Product Change Notification / GBNG-17ZWEX736

CCB 4959 Final Notice: Qualification of MMT as a new assembly site for selected SMSC LAN91C11xx device family available in 128L TQFP (14x14x1mm) package.

CCB 4959
Pre and Post Change Summary
PCN #: GBNG-17ZWEX736

LEAD FRAME COMPARISON

ASE

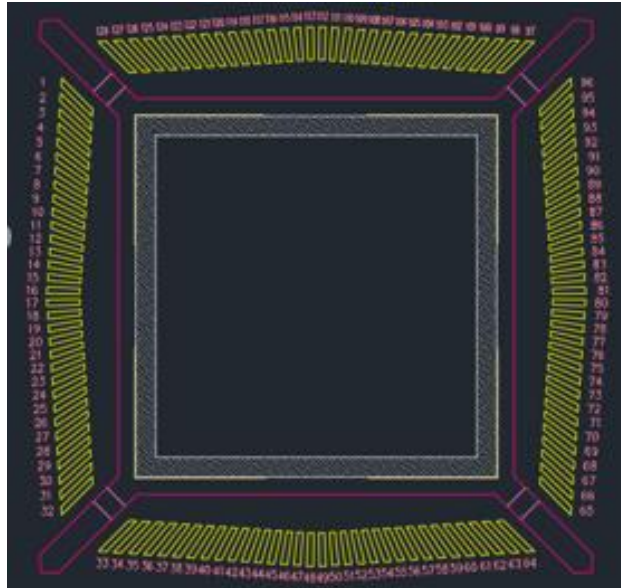
Lead frame paddle size	240 x 240 mils
Lead frame DAP surface prep	Double Ring

MMT

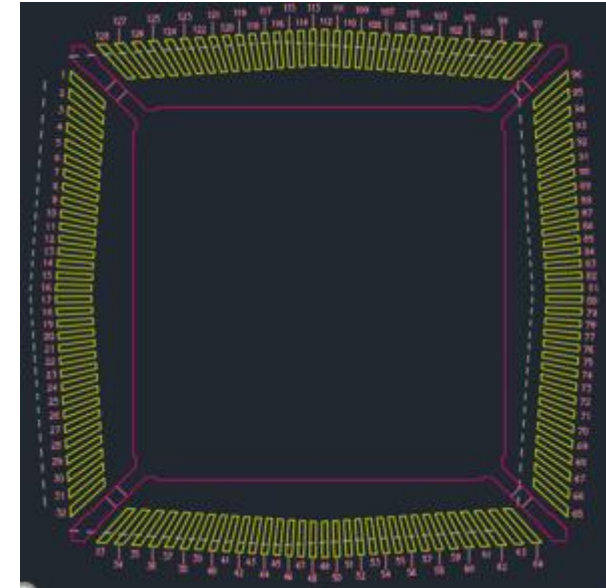
Lead frame paddle size	252 x 252 mils
Lead frame DAP surface prep	Bare Cu
